NO-04-0001
January 9, 2004

SUBJECT: Quality Assurance Program (QAP) Topical Report - Millstone Power Station
Revision 25, Change 2 (Document No. MP-02-OST-BAP01)

Summary of Changes to QAP Rev. 25 Incorporated as Change 2

**Organizational Relationship
of Functional Groups Having Quality
Functions for Millstone
Power Station**

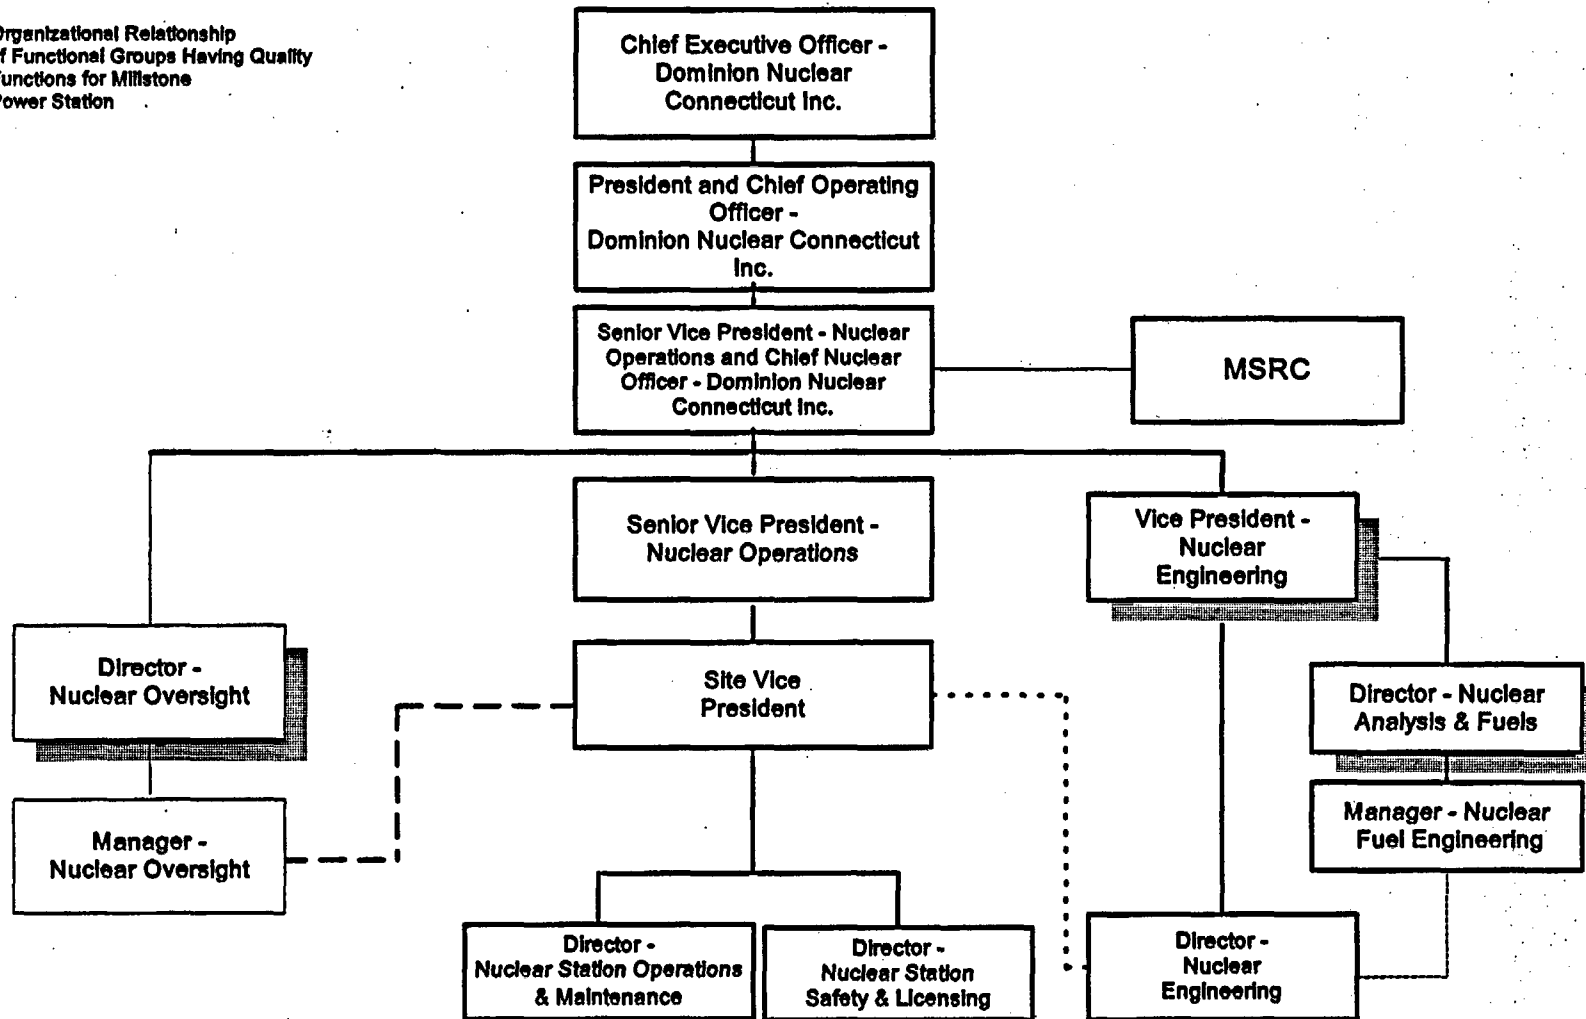
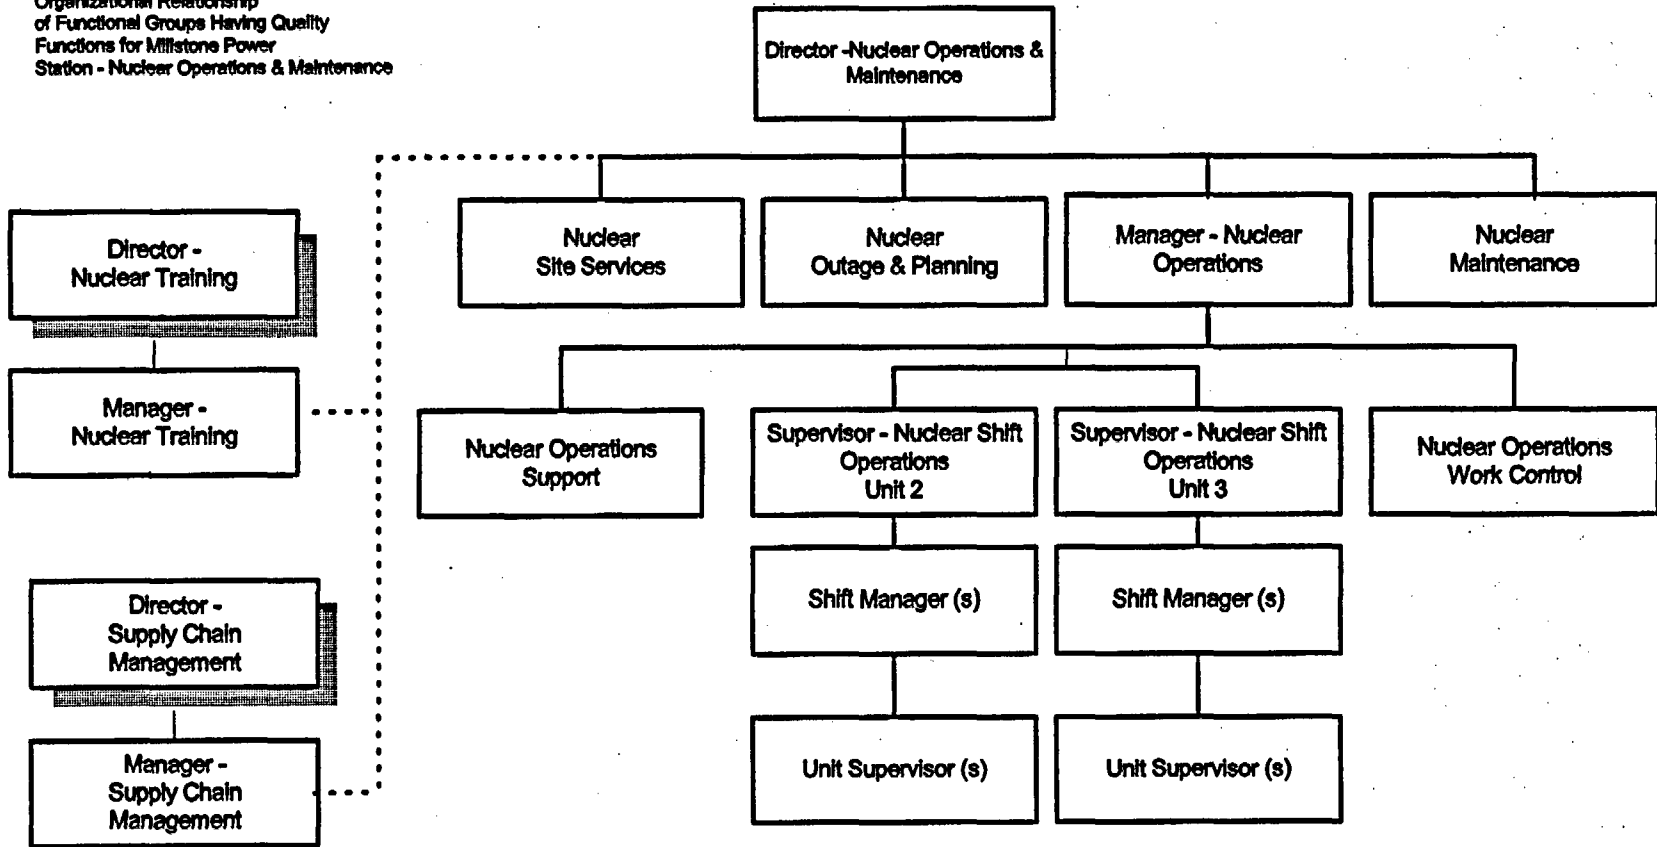
<u>Section</u>	<u>Summary Description of Changes</u>	<u>Reference</u>
QAP 1.0	Modified QAP Section 1.0, Organization, sections 1.3.4, 1.3.8 and 1.3.16; and Figure 1.2 to reassign the reporting relationship for the fire protection group from Protection Services to Nuclear Operations.	Request 03-07

Enclosed please find Quality Assurance Program (QAP) Topical Report - Millstone Power Station, Revision 25, Change 2. The change reassigns the reporting relationship for the fire protection group from Protection Services to Nuclear Operations. QAP Section 1.0, Organization, sections 1.3.4, 1.3.8, 1.3.16, and Figure 1.2, are modified to reflect this change. The change does not impact the roles or responsibilities of the fire protection function, but merely transfers those responsibilities from Protection Services to Nuclear Operations.
